## **DEVELOPMENT APPLICATION ASSESSMENT REPORT**

Application Number:	DA2022/1769		
Responsible Officer:	Grace Facer		
Land to be developed (Address):	Lot 3 DP 334910, 5 Roches Avenue BAYVIEW NSW 2104		
Proposed Development:	Alterations and additions to a dwelling house		
Zoning:	R2 Low Density Residential		
Development Permissible:	Yes		
Existing Use Rights:	No		
Consent Authority:	Northern Beaches Council		
Land and Environment Court Action:	No		
Owner:	Patrick Kevin Keane Beryl Ann Keane		
Applicant:	SKL Planning Pty Ltd		
Application Lodged:	01/11/2022		
Integrated Development:	No		
Designated Development:	No		
State Reporting Category:	Residential - Alterations and additions		
Notified:	04/11/2022 to 18/11/2022		
Advertised:	Not Advertised		
Submissions Received:	3		
Clause 4.6 Variation:	Nil		
Recommendation:	Approval

Aerial Photograph 1: Subject site indicating orientation of views towards Pittwater

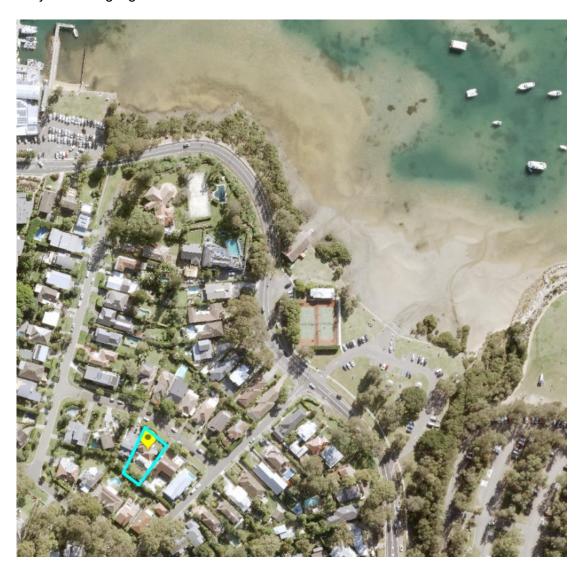
The affected views are water views over Pittwater which are largely unobstructed, with some vegetation screening the views from surrounding properties. The relationship of surrounding properties in relation to the direction of views towards Pittwater is depicted below, with the subject site highlighted.
